UNITED STATES ENVIRONMENTAL PROTECTION AGENCY
REGION III
1650 Arch Street
Philadelphia, Pennsylvania 19103-2029
7/1/2008

On June 30, 2008, the U.S. Environmental Protection Agency (EPA), Region III, established Total Maximum Daily Loads (TMDLs) for the following waters and pollutants: total phosphorus and sediment for the Indian Creek Watershed, total phosphorus and sediment for Southampton Creek Watershed, total phosphorus and sediment for Paxton Creek Watershed, total phosphorus for Goose Creek Watershed and total phosphorus for Sawmill Run Watershed. These TMDLs were established in accordance with Section 303(d)(1)© and (2) of the Clean Water Act to address impairments of water quality as identified on Pennsylvania's Clean Water Act Section 303(d) List of impaired waters. These TMDLs were completed to partially fulfill the 1997 TMDL Consent Decree requirements and at the request of the Pennsylvania Department of Environmental Protection.

**Nutrient
Total Maximum Daily Load in
Sawmill Run Watershed,
Pennsylvania**

**Established by United States Environmental Protection Agency
Region III
June 30, 2008**

Figure 2-1. Sawmill Run Vicinity Map

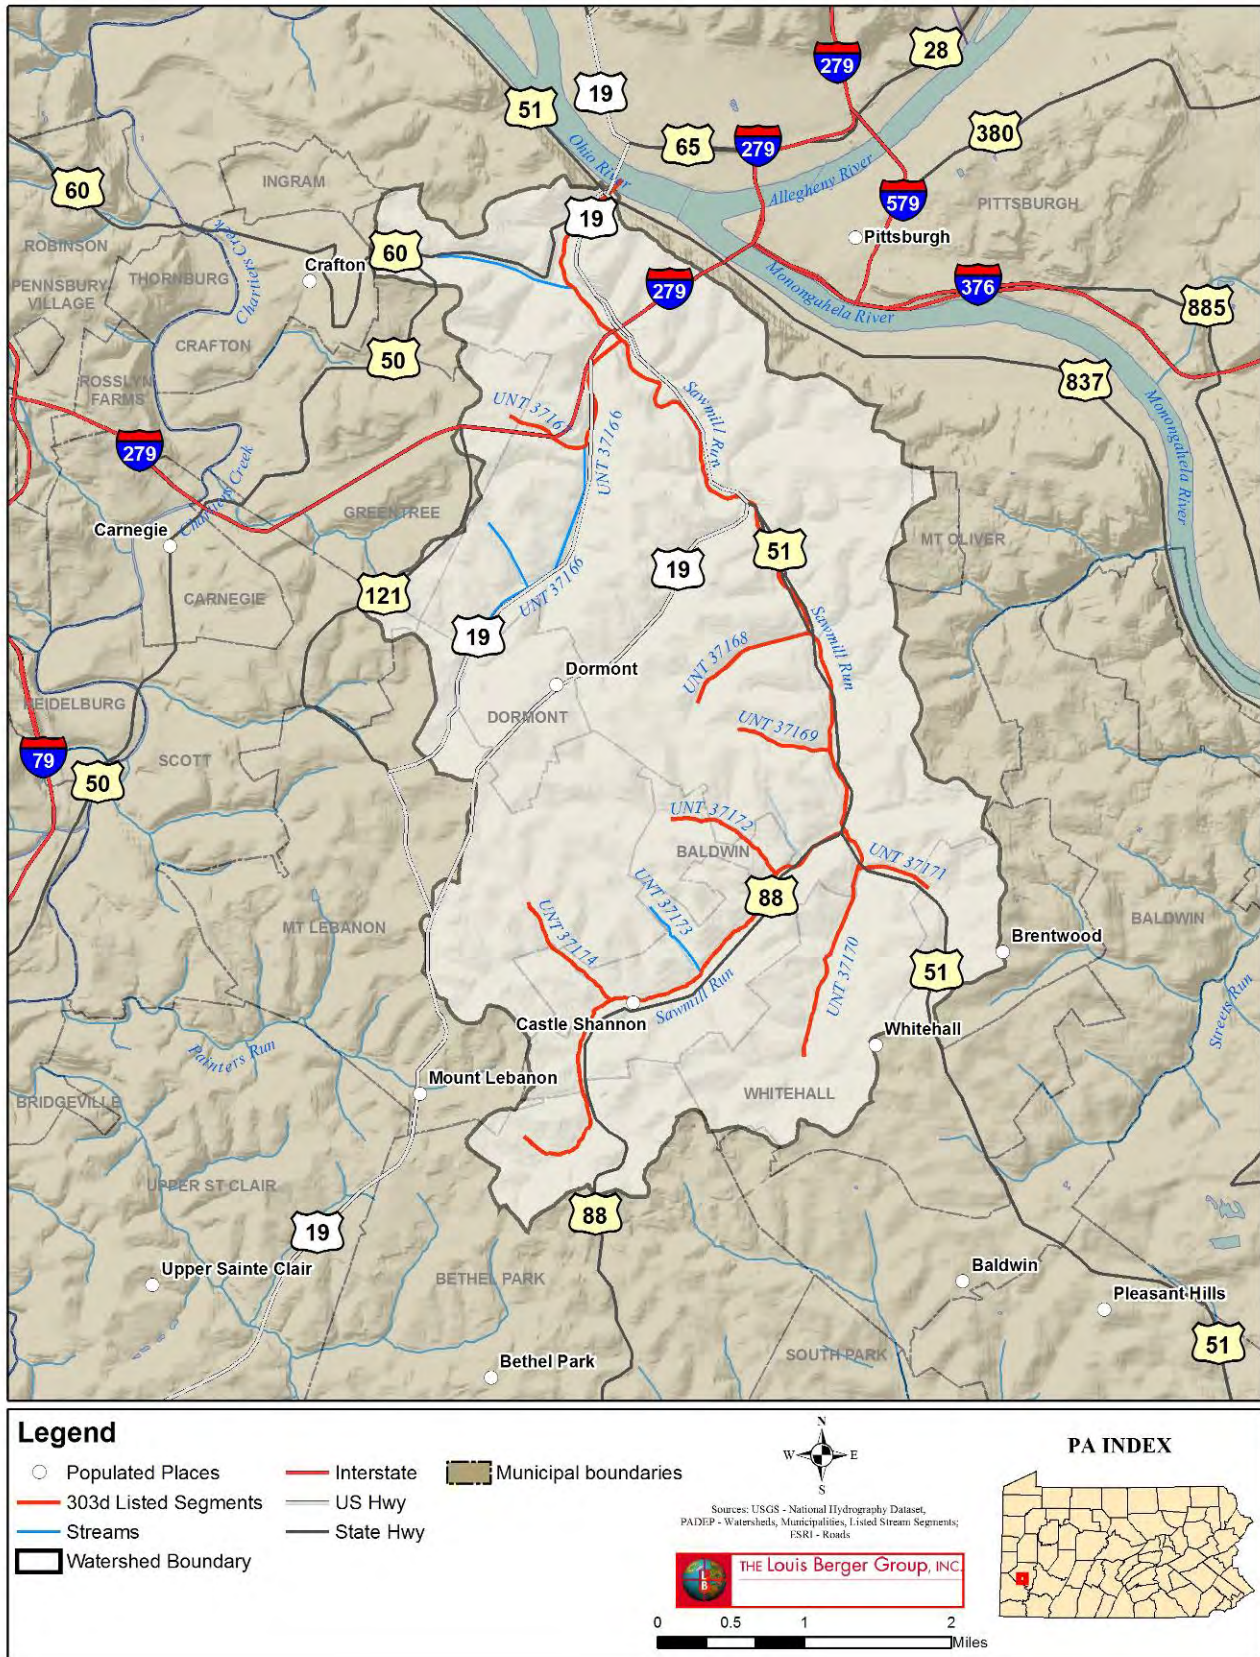
Comment 2: Table 2-11 of the draft TMDL lists all of the "...MS4 permit holders...". The information contained in this table is inaccurate. A number of state highways, as identified in Figure 2-1 of the draft TMDL, traverse the Sawmill Run Watershed. Castle Shannon Borough understands that the Pennsylvania Department of Transportation (PennDOT) has its own MS4 permit which identifies its responsibilities for state owned facilities. Although no County owned roadways were identified in the draft TMDL, it is important to note that Allegheny County also has its own MS4 permit, which identifies responsibilities for county owned facilities. Given the allocation of Total Phosphorus loads to MS4 permittees, this information must be accurate and taken into consideration when allocating loads for Total Phosphorus.

Figure 2-10. CSO Outfall Locations in the Sawmill Run Watershed

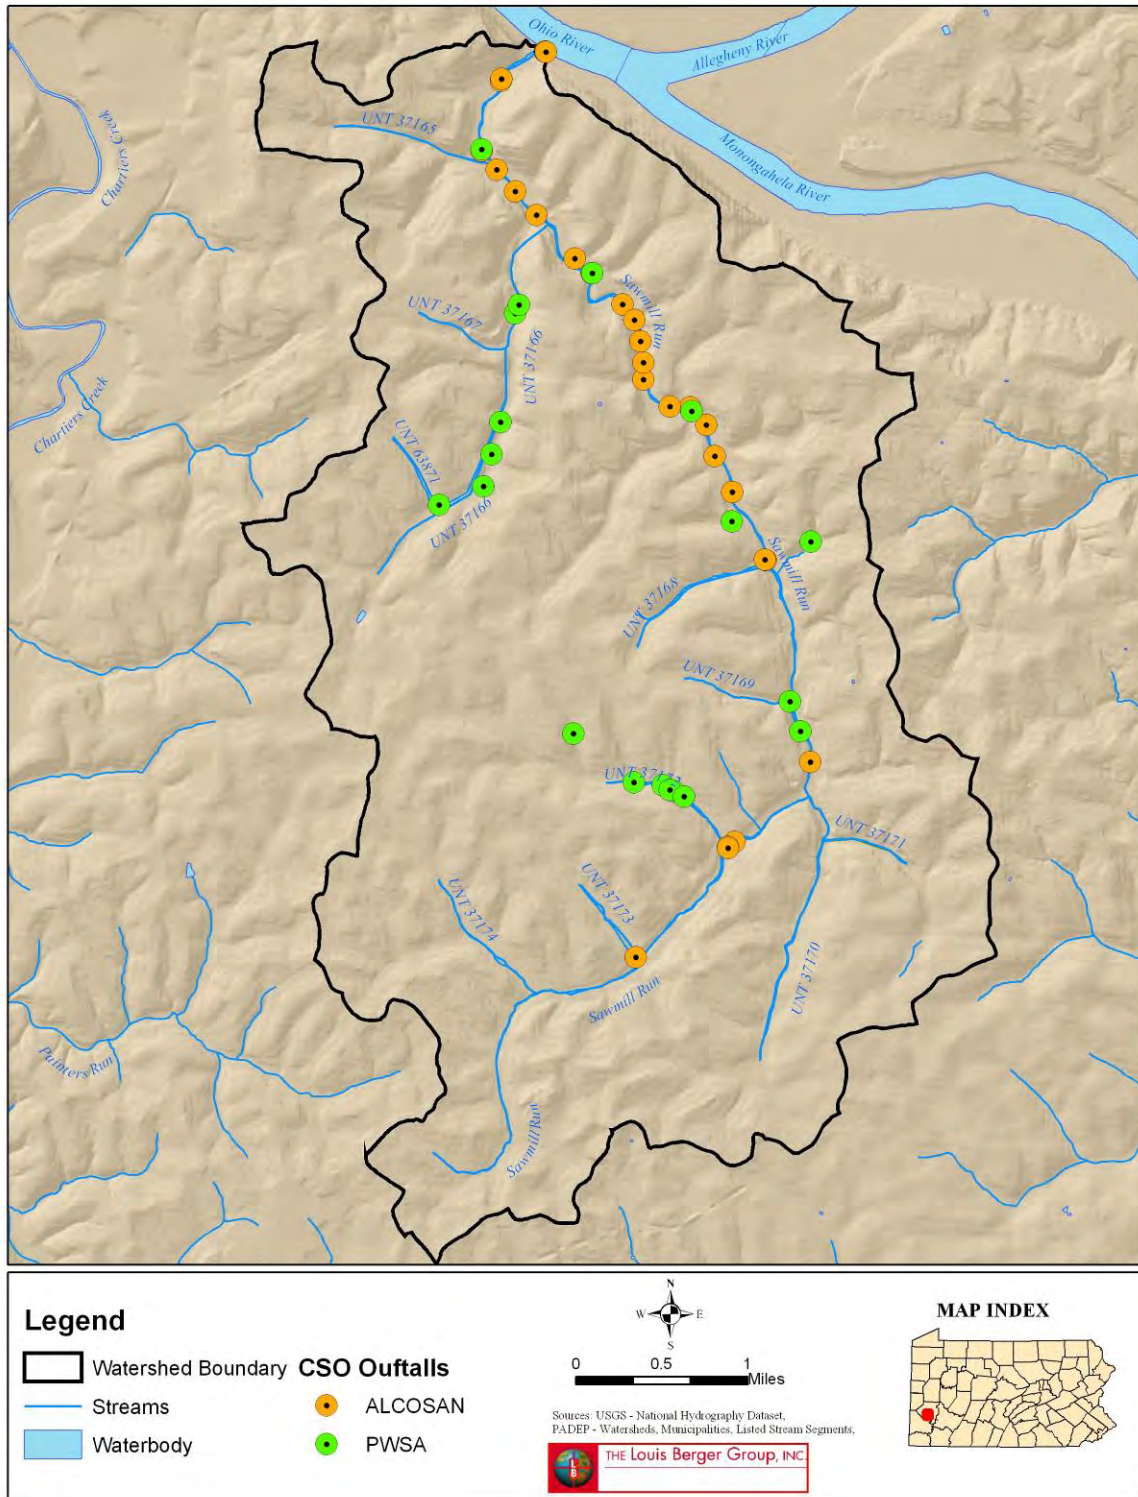
Comment 4: Also, there is no information characterizing the volume or concentrations from the Combined Sewer Overflows (CSO). Figure 2-10 in the report provides the location of these CSO outfalls in the watershed. It must be stated that these CSO structure are owned and operated by Pittsburgh Water and Sewer Authority and are out of the control of Baldwin Township, Pennsylvania. The control and implementation of appropriate levels of TMDL loading would be by PWSA at those point source locations. In order to develop and achieve appropriate water quality levels for aquatic life, a testing, sampling and monitoring program is needed.

Figure 3-6 Maximum, Average, and Minimum Concentration for Total Iron at stations on Sawmill Run

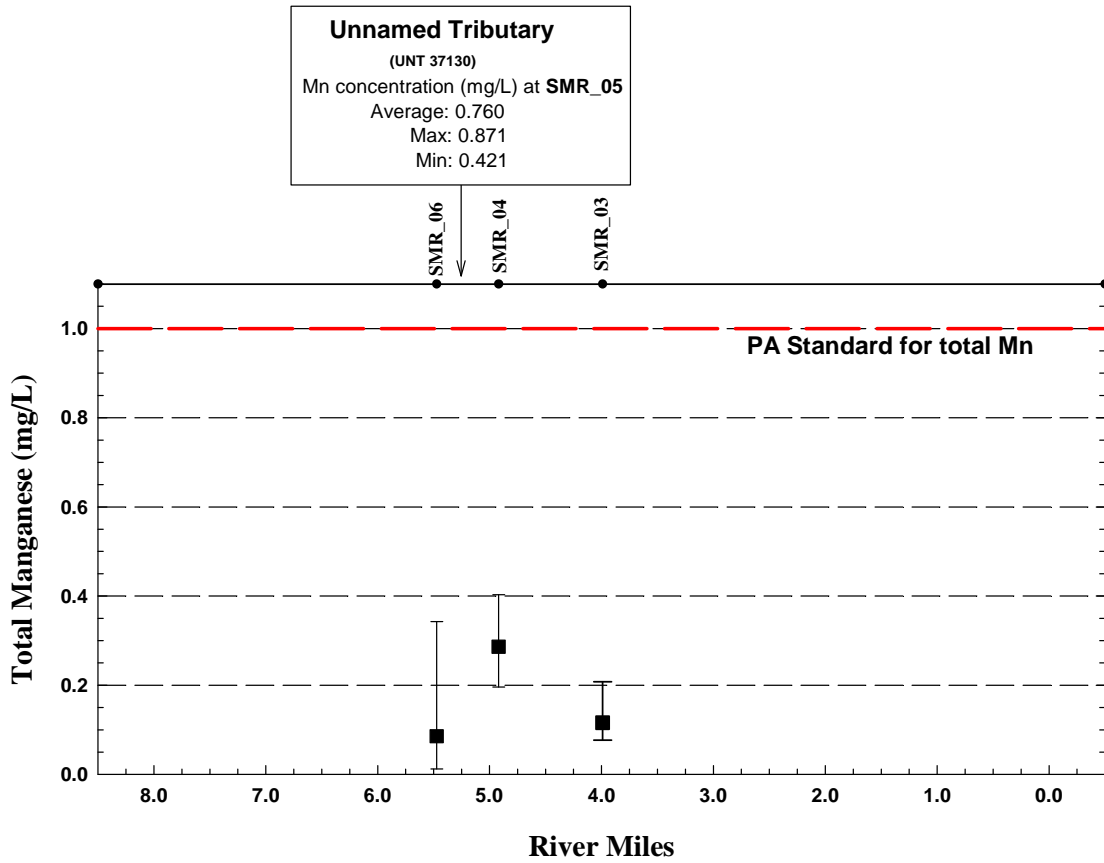
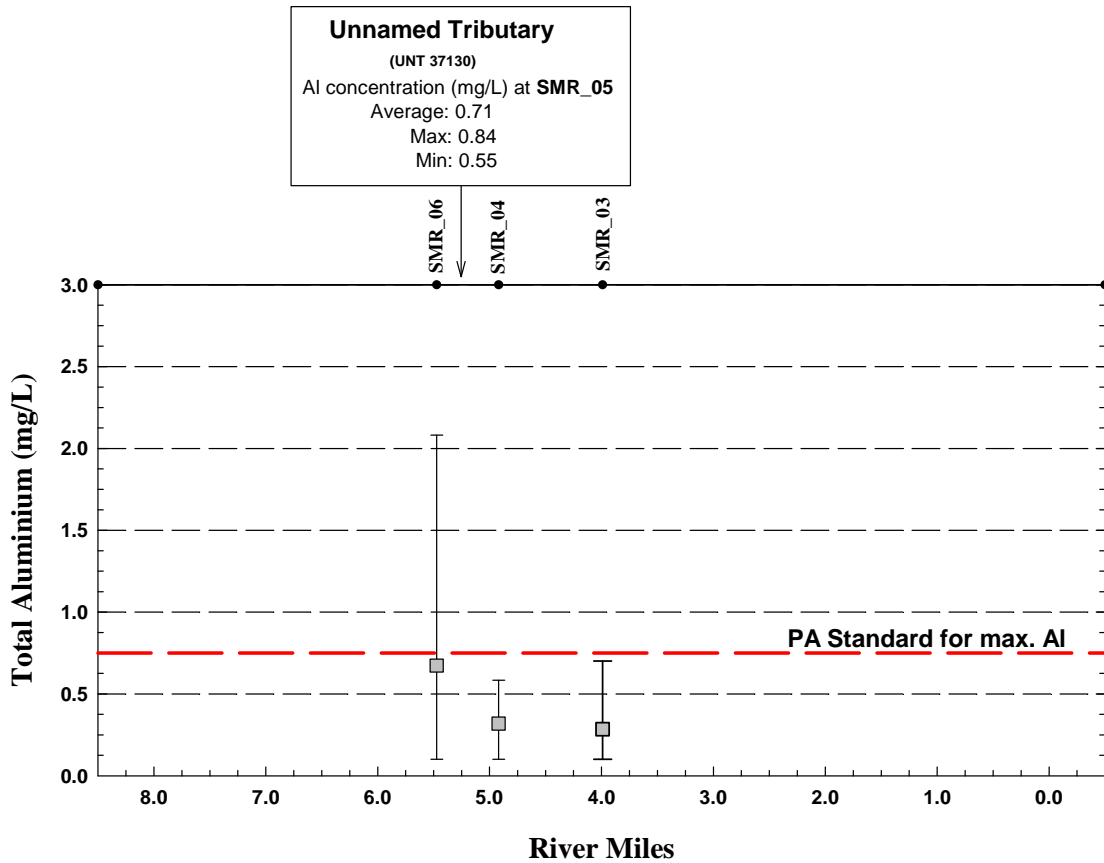
Sub 6: The DO swing data presented in the report show that minimal DO variation is present and that variation does not cause any DO standard violations. (Figures 3-6, 3-7 and Appendix A) In fact, the DO levels presented in the TMDL report for 2006 are generally excellent. These data confirm that the state's narrative standard for nutrients is not violated. DO swings are caused by two events: changes in temperature and changes in plant respiration. The data show that DO variations are highest in May and lowest during the period when peak aquatic plant growth would be expected - August and September. (Table 3-1) The highest DO swings occurred in Paxton Creek when the lowest TP levels were present.¹⁶ Thus, elevated TP readings identified in EPA's July- September 2006 monitoring have no relationship to plant growth. EPA has simply regulated the wrong pollutant with no apparent connection to the instream conditions of concern.

Figure 3 – Figure 6 from the evaluation

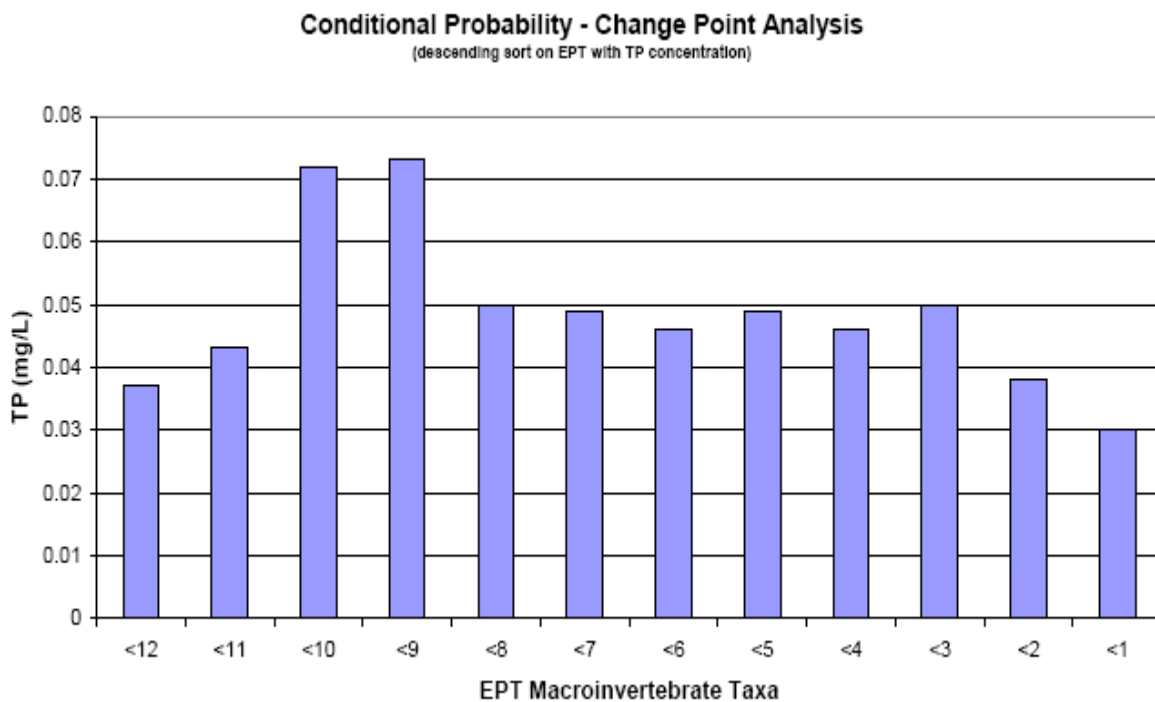
The author recalculated conditional probabilities using a range of different conditions (e.g., from <2 to < 14 EPT Taxa) and re-ran the change-point analyses. What he discovered is that across this range, the TP threshold remains constant (Figure 3).

He concludes that “the number of EPT taxa is insensitive to the TP concentration”. But Figure 3 is not a plot of TP versus biological condition. It simply demonstrates that no matter what biological condition one chooses, the risk of losing EPT taxa increases dramatically between 30 and 50 ug/L, which is actually consistent with what the raw data show in Figure 2 above. What the evaluation fails to recognize is that relative to any biological condition (e.g., EPT<2), the probability of encountering that condition starts to increase rapidly above 40 ug/L. Rather than showing that “the number of EPT taxa is insensitive to the TP concentration”, what the author has shown in Figure 3 is that across the range of conditions, there is a dramatic decline in the number of EPT taxa above 40 ug/L. Whether one uses a conditional probability of having fewer than 14 taxa or fewer than 3 taxa, above 40 ug/L, the likelihood of losing EPT taxa in Piedmont streams increases after showing little response to TP below 40 ug/L. This simply reinforces what is evident by looking at the raw data in Figure 2 above on the left. Again, whether one is looking at EPT taxa loss risk relative to 14
